Commonwealth Edison
One First National Plaza, Chicago, Illinois
Address Reply to: Post Office Box 767
Chicago, Illinois 60690

Subject: Dresden Station Units 2 and 3
Additional Information on
Appendix R (Fire Protection)
NRC Docket Nos. 50-237 and 50-249

RESPONSE TO NRC QUESTIONS

APPENDIX R - DRESDEN

Figure 1 and 2 show typical schematic diagrams.

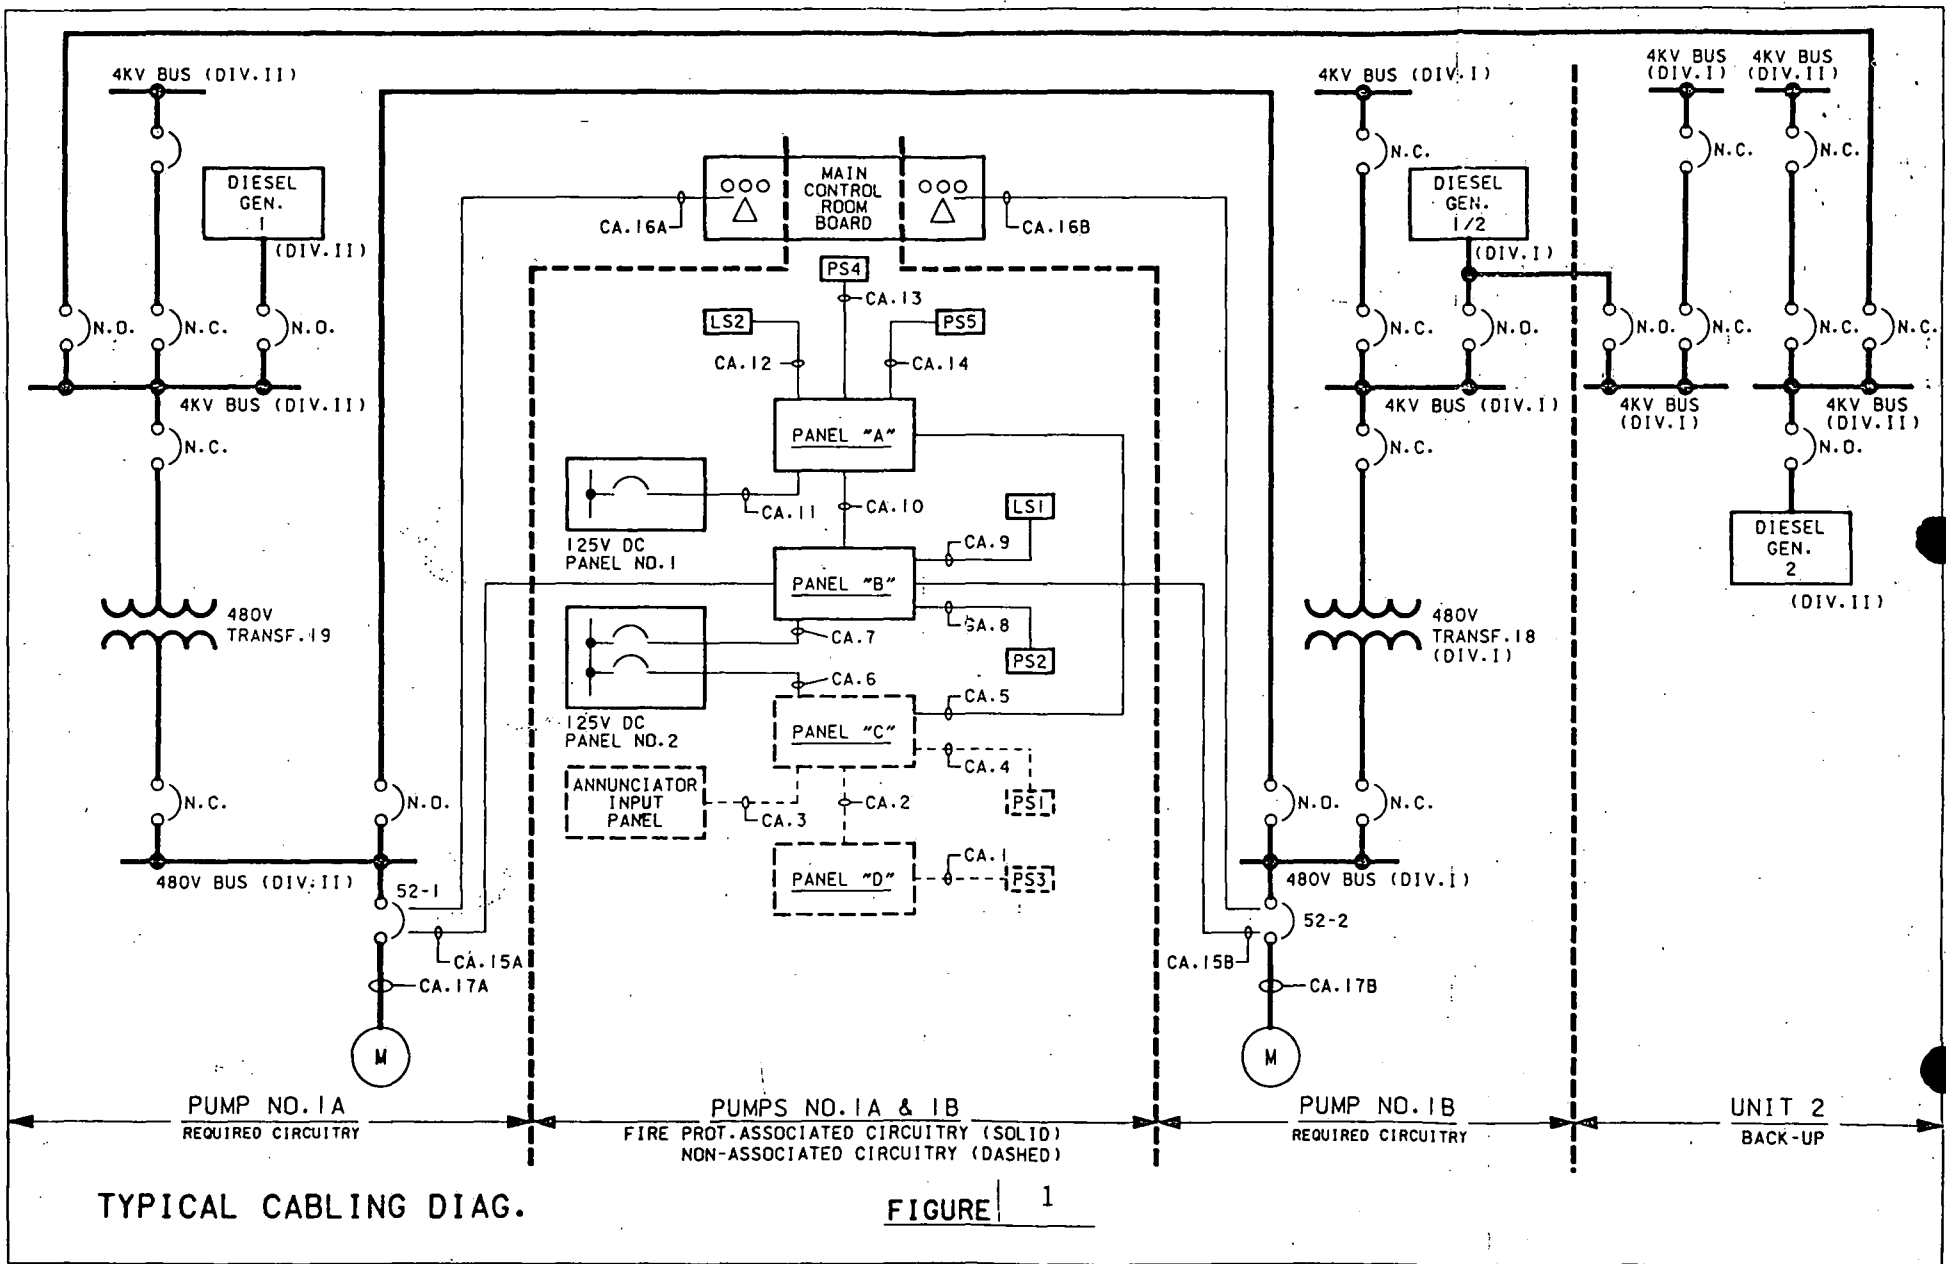
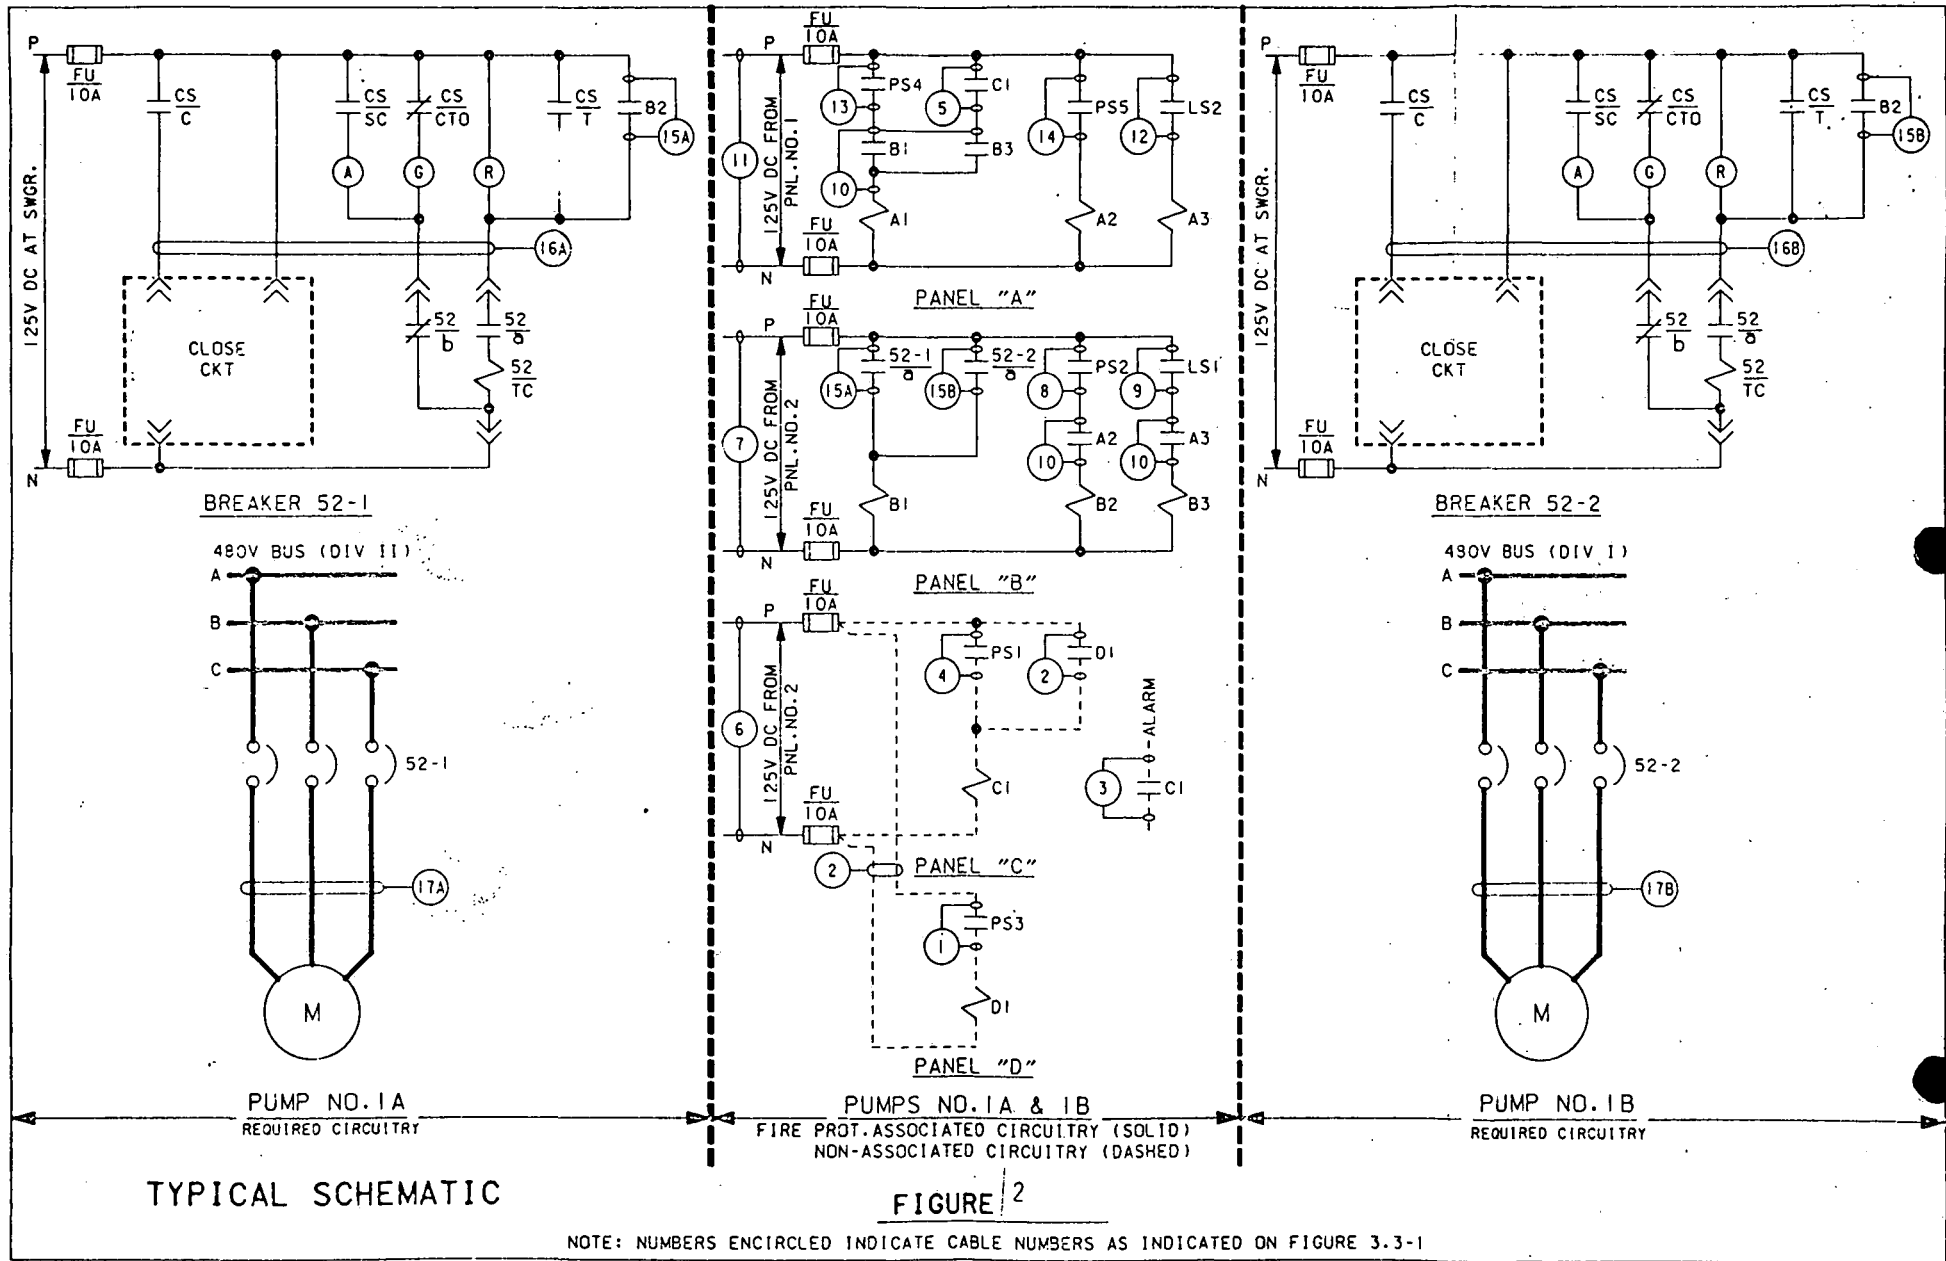
- a. The circuits that may affect the normal automatic and manual operation of safe shutdown systems and components due to fire induced faults were identified using the electrical schematic and wiring diagrams. These circuits include the normal control and power circuits for safe shutdown components and the interlocks between the safe shutdown component control circuit and other circuits.
